NUCLEAR REGULATORY COMMISSION

Title: Advisory Committee on Reactor Safeguards
Plant License Renewal Subcommitee
Prairie Island Nuclear Generating Station

Date: Tuesday, July 7, 2009

Switchyard Scoping Boundary

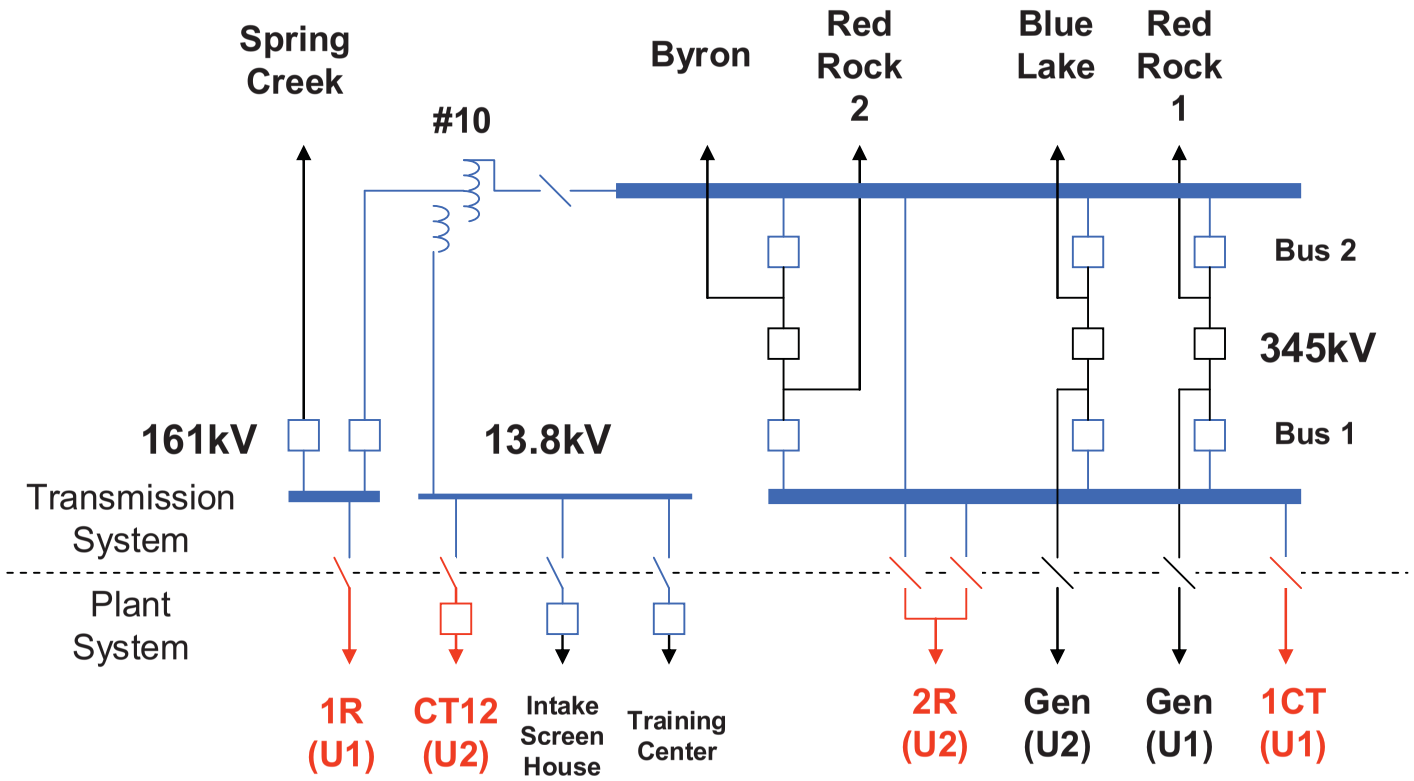
1 One other thing to note is that the switchyard
2 scoping boundary in the Prairie Island LRA does
3 include breakers at the transmission system voltage.
4 MR. BARTON: Question on your scoping,
5 please.
6 I noticed you have site lighting as
7 listed as in scope for license renewal. It's the
8 first application I've seen with site light. What's
9 different about your site lighting?
10 MR. ECKHOLT: Joe, maybe you'd like to
11 touch on that.
12 MR. RUETHER: This is Joe Ruether. We took
13 a bounding approach, so we brought all electrical
14 components in and dealt with the scoping screen on a
15 commodity basis.
16 So it didn't make any difference what the
17 -- site lighting was basically all the components for
18 electrical and brought into scope.
19 MR. BARTON: Okay, thank you.
20 MR. ECKHOLT: The next slide is a
21 simplified drawing of our switchyard, showing in red
22 those components that were brought into scope based

Typical Reactor Vessel Internals Stand Support

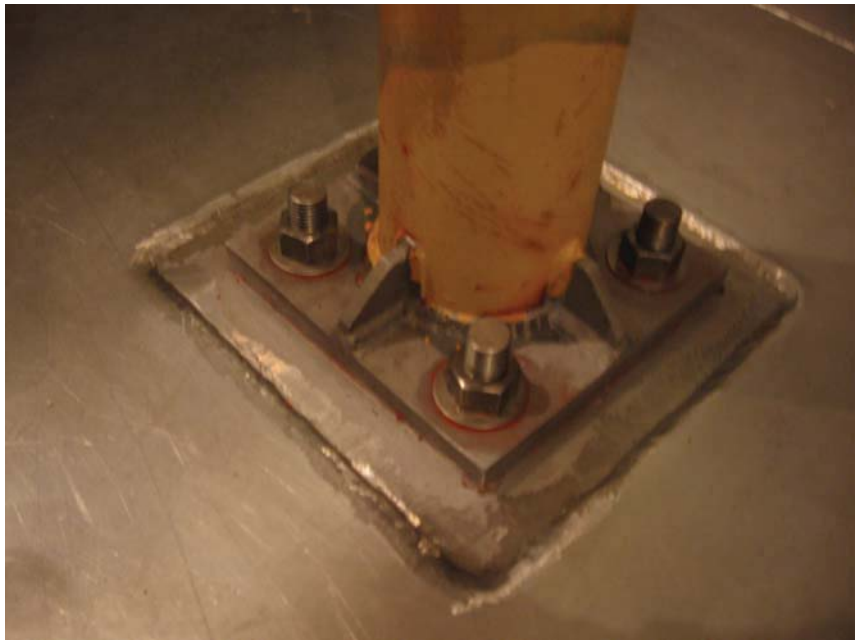
1 MR. ECKHOLT: That's basically down --
2 MR. SKOYEN: 693 elevation.
3 MEMBER MAYNARD: That's at the bottom of
4 that thing over on the right.
5 MEMBER ARMIJO: You have a slide 51, page
6 51, that's shows the ECCS sump. Is that one of those
7 locations that where you're finding the water?
8 MR. SKOYEN: That's correct. That's the
9 location that we're referring to on this particular
10 slide, in the center -- the cut-away drawing in that
11 particular location.
12 And you'll note that the grout between
13 the containment pressure vessel itself and the sump
14 is relatively thin in that particular area.
15 MR. ECKHOLT: This area here.
16 MEMBER ARMIJO: This looks thicker there
17 also, for some reason.
18 MR. SKOYEN: Correct. That's a penetration
19 so it has some reinforcements. That's approximately
20 three and a half inches. Next slide, Gene.
21 The actual leak locations themselves, the
22 typical reactor vessel internals support stand is in

23 the left and the typical RCC change fixture support
24 stand is on the right. There are eight internal
25 support stands and we have three NRCC change fixture

The leakage, we believe to be flowing the threads down past the nut. Once past the nut, there's a seal weld -- this is the RCC change fixture -- seal weld that was installed when this was originally put in.

MR. SKOYEN: Yes. Past actions that we've taken, most recently was caulking and we would remove the nuts from the top of the base plate, underneath those nuts to prevent the leakage from going past the threads. Then between the base plate and the embedment plate, we would try to caulk there.

Refueling Cavity Leakage Path

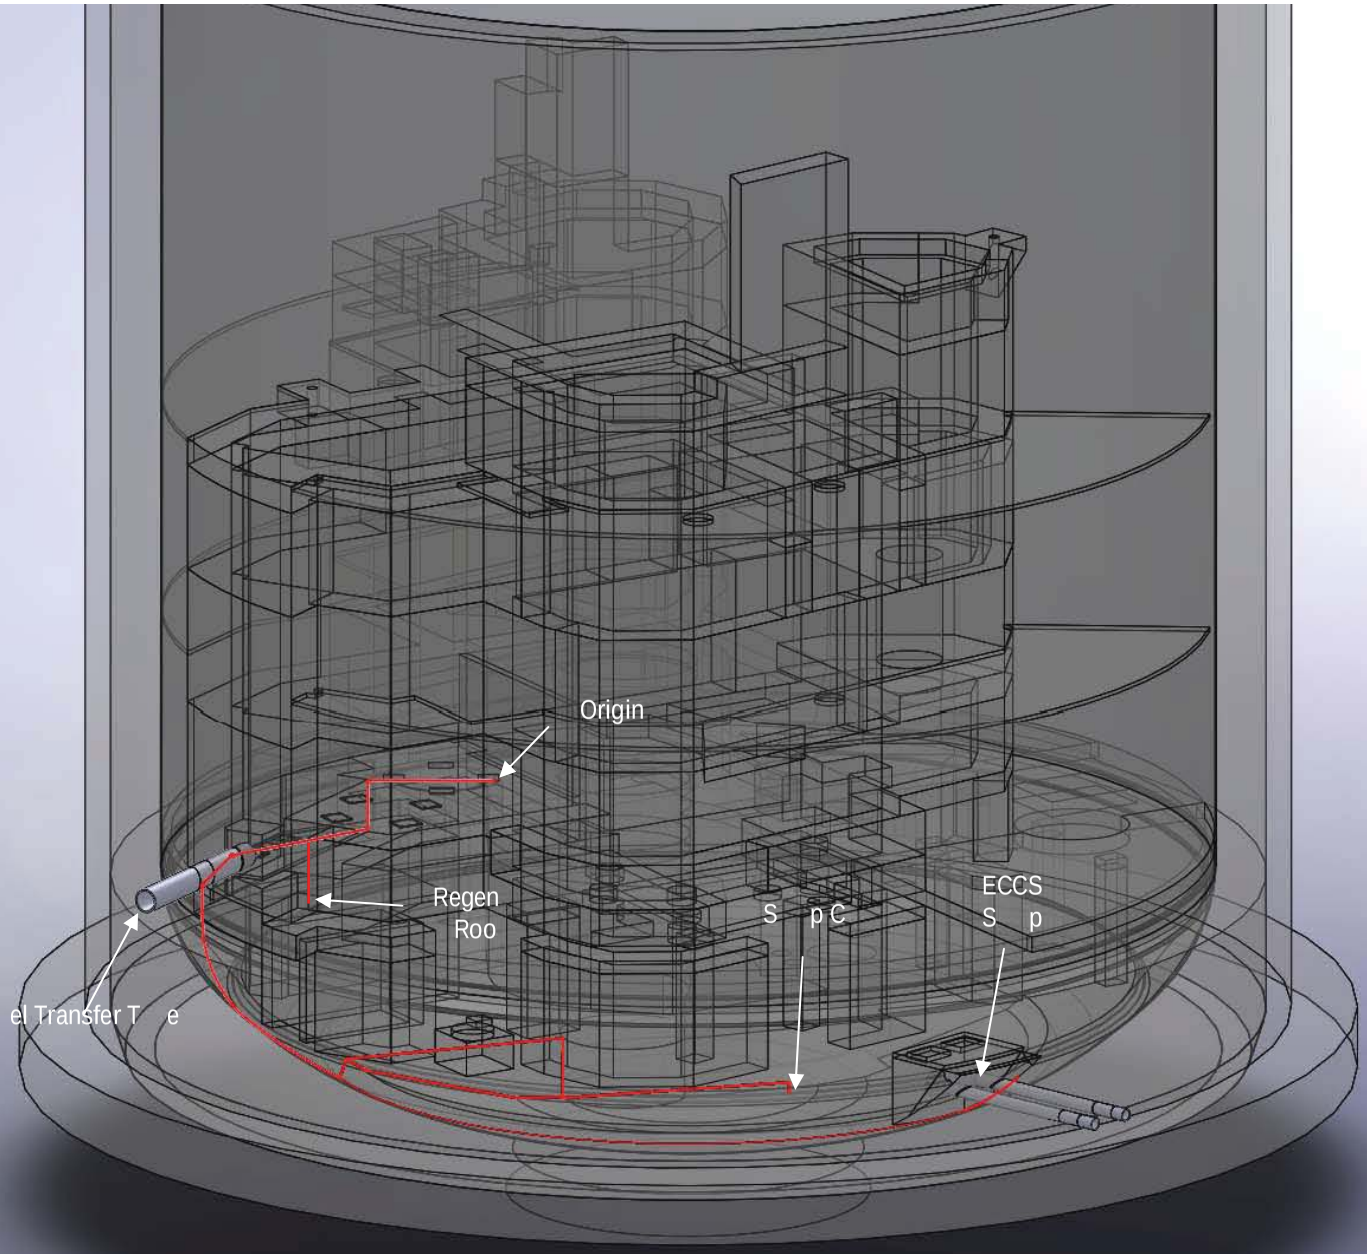
MR. SKOYEN: Okay, the top view, you'll notice our ECCS sump -- that's at an elevation of 693.7. 693 and 7 inches. We didn't see that in the prior view because it was in a different plane. That's typically where the leakage would show up, in that particular location.

Refueling Cavity Leakage Corrective Actions - Repair Method

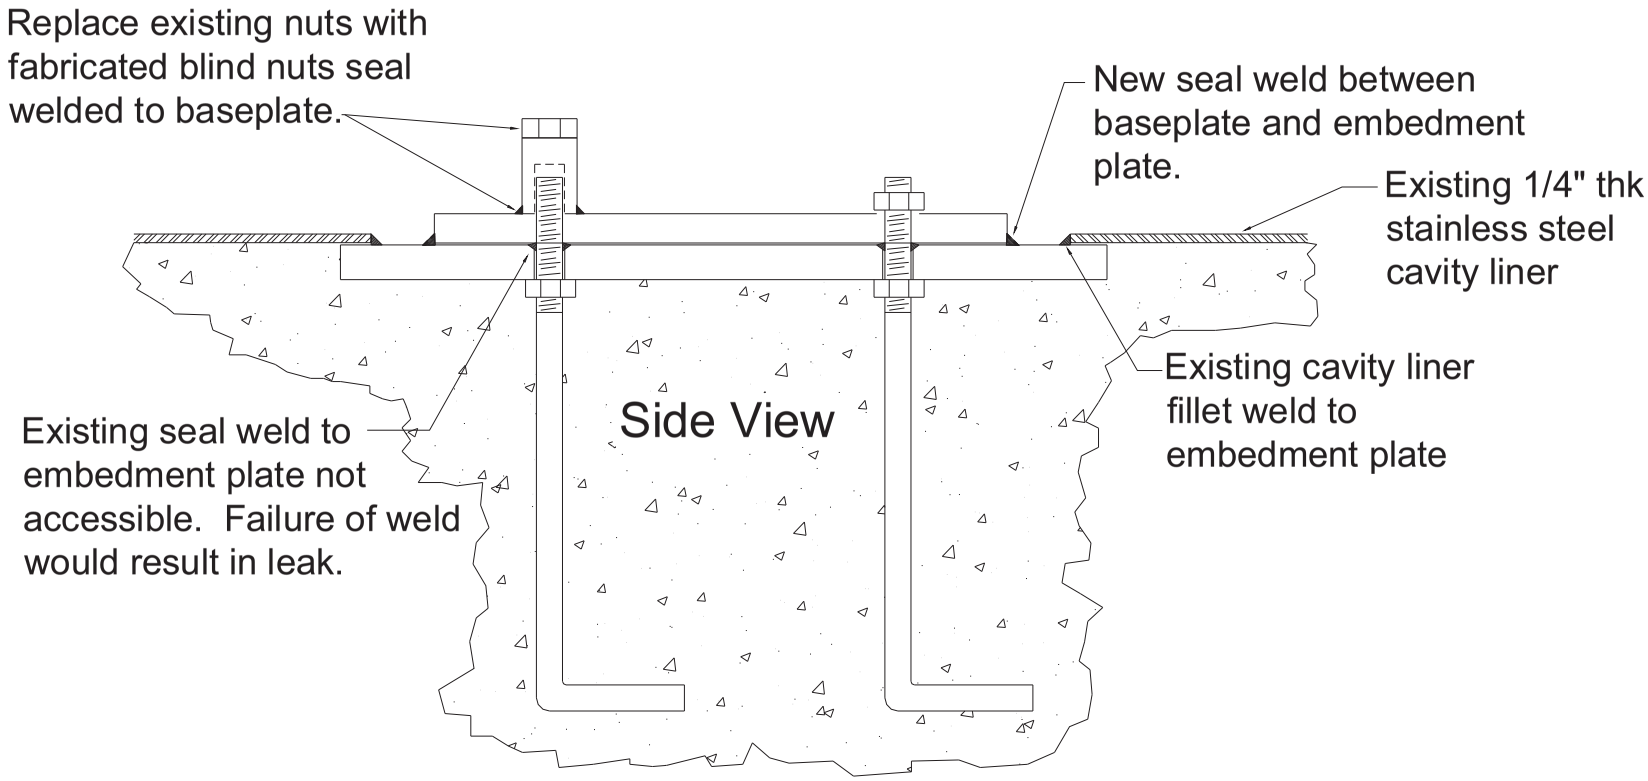
1 permanently eliminate the leakage that occurs from
2 both the internal stands and the RCC change fixture
3 support stands.
4 MEMBER ARMIJO: There was no seal weld
5 there initially?
6 MR. BARTON: There was initially. They
7 said down here, they think that --
8
9 MEMBER ARMIJO: Yes, just around the
10 threads.
11 MR. SKOYEN: Yes. Just around the threads.
12 So we believe this to be a much more
13 robust design than was the original. It also allows
14 us to inspect these welds going forward and identify
15 any concerns with those in repair.
16 It also, from a dose consideration,
17 perspective, is we receive far less dose employing
18 this method of repair than going back to the original
19 drawing.
20 So for a number of reasons, we believe
21 this is the correct method for repair.
22 CHAIRMAN RAY: I take for granted that
23 there aren't any leak chases on the seams of the
24 cavity and so on.
25 MR. SKOYEN: That's correct, right.

- **Perform Repairs to Eliminate Leakage During Next Refueling Outage of Each Unit**
  - **Unit 1 – September 2009**
  - **Unit 2 – April 2010**

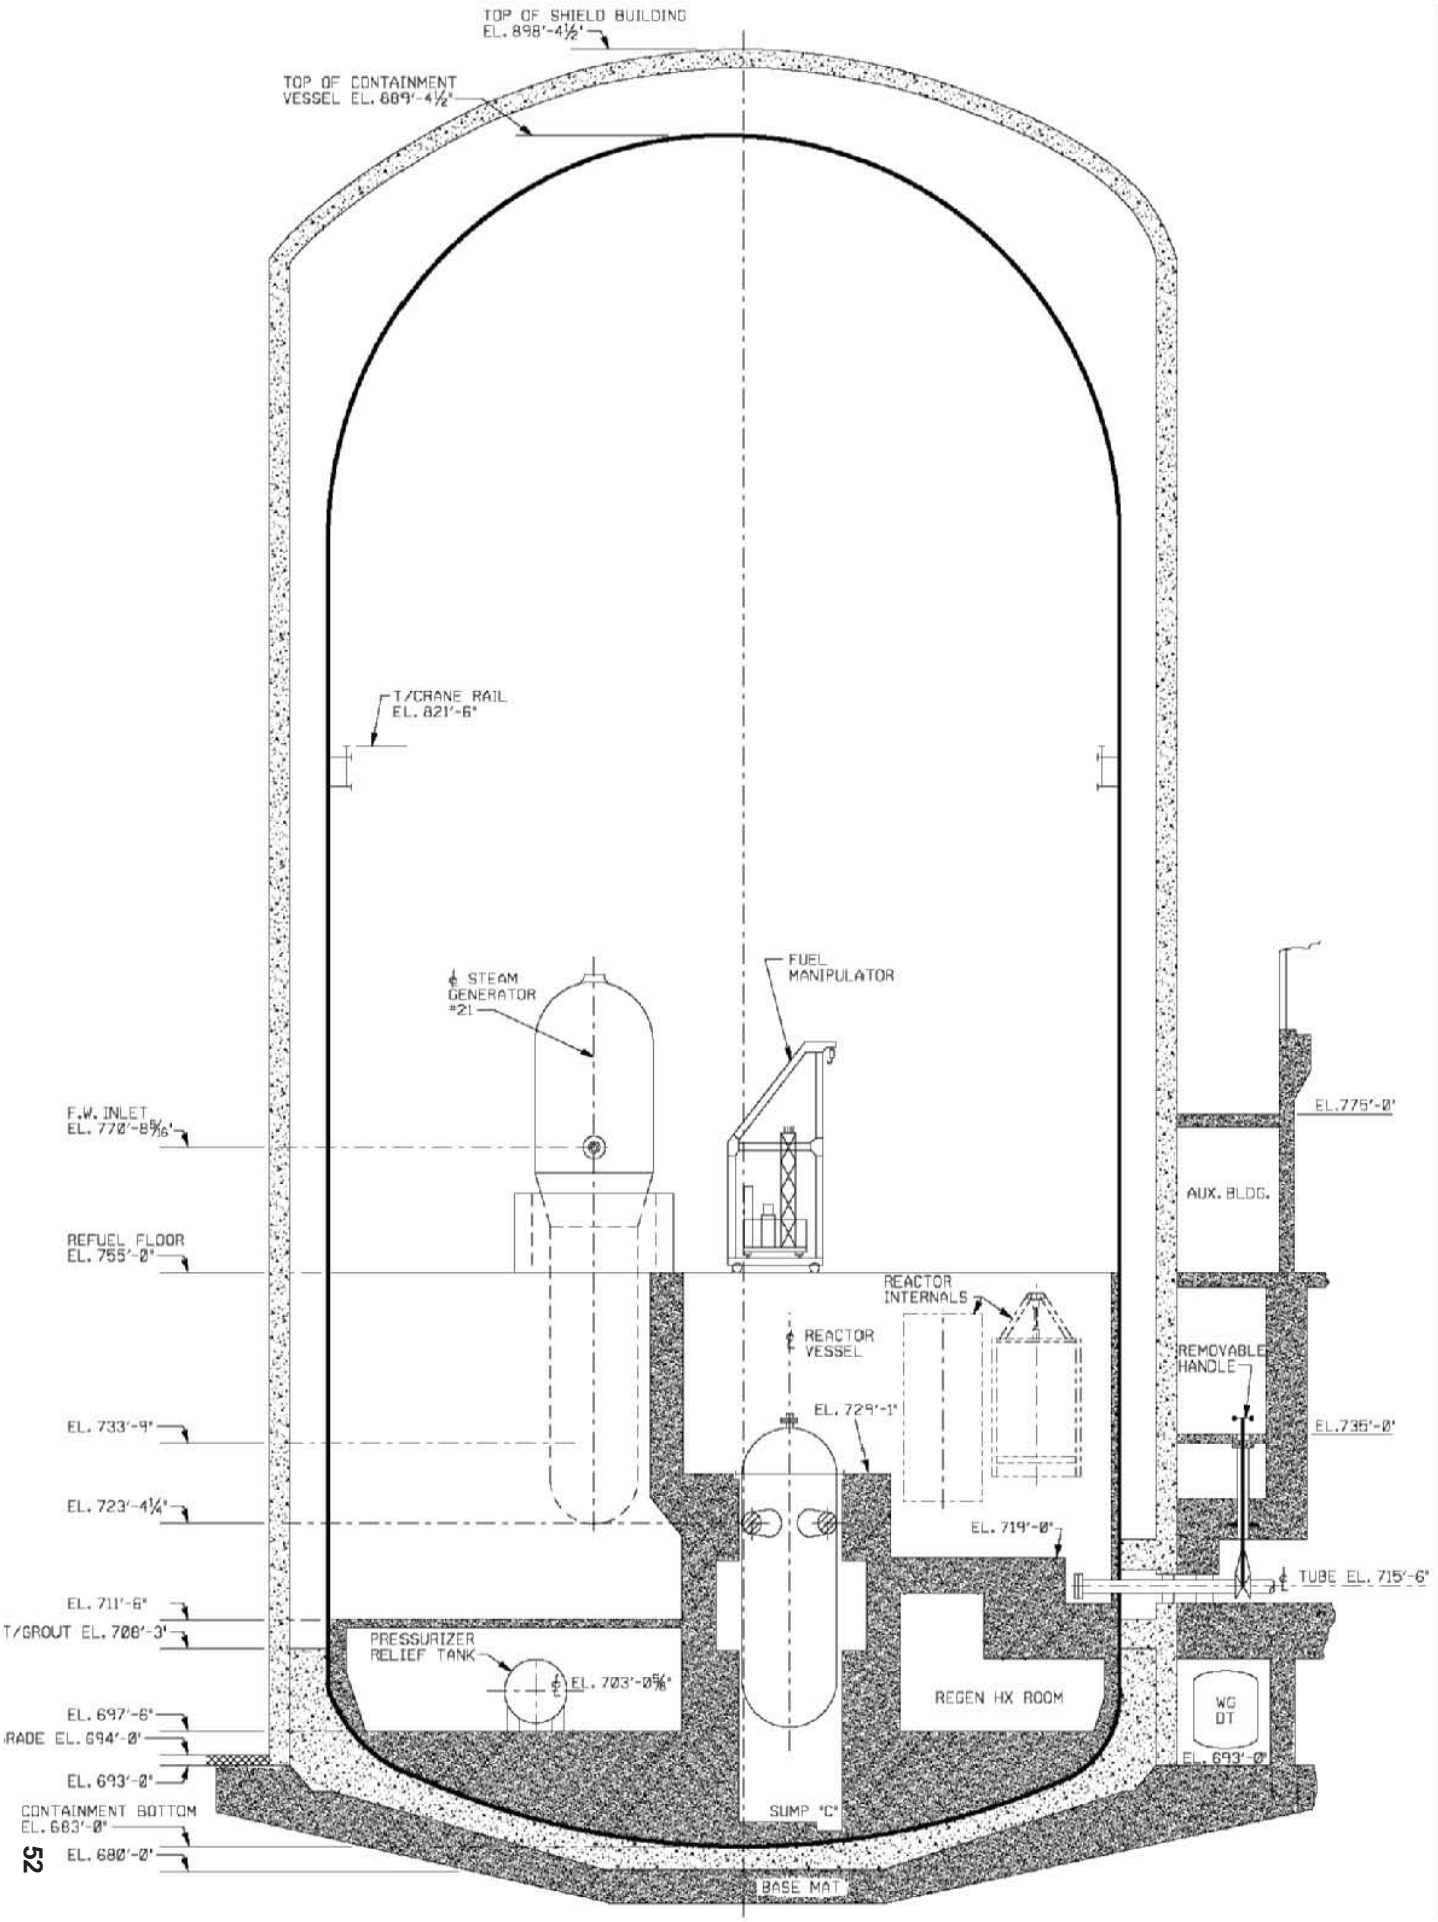
The lower head, as you can see in the drawing, is fully encased in concrete on both sides. The remainder of the containment pressure vessel -- and there's a five foot annular gap between the containment vessel itself and the one in the leakage -- reinforce the concrete shield building. That allows us access to the vast majority of the containment pressure vessel itself.

MR. SKOYEN: Can we go back to the cut-away drawing again, the elevation drawing. It may b easier to see here.
